UNITED STATES  
NUCLEAR REGULATORY COMMISSION  
WASHINGTON, D.C. 20555-0001

WOLF CREEK GENERATING STATION

AMENDMENT TO FACILITY OPERATING LICENSE

Amendment No. 99  
License No. NPF-42

FIGURE 2.1-1  
 REACTOR CORE SAFETY LIMIT - FOUR LOOPS IN OPERATION

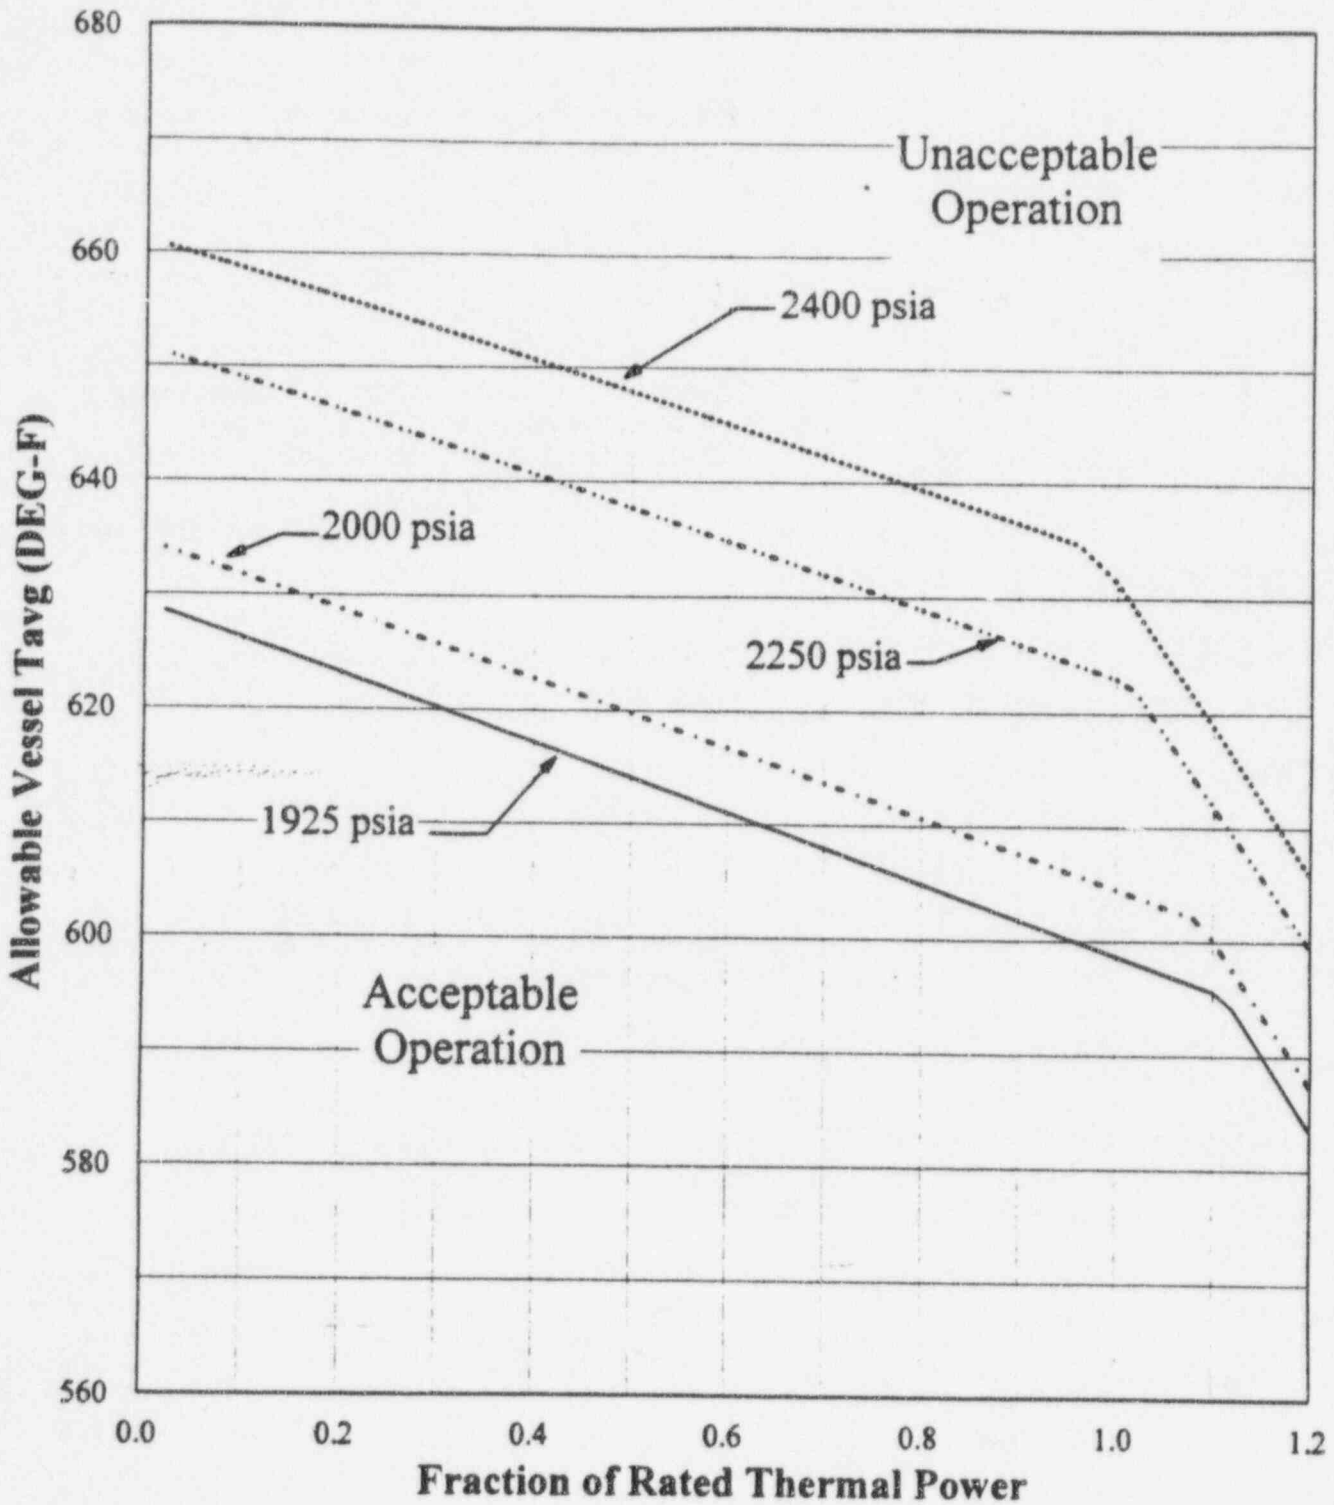
2.1.1 The combination of THERMAL POWER, pressurizer pressure, and the highest operating loop coolant temperature ( $T_{avg}$ ) shall not exceed the limits shown in Figure 2.1-1 for four loop operation.
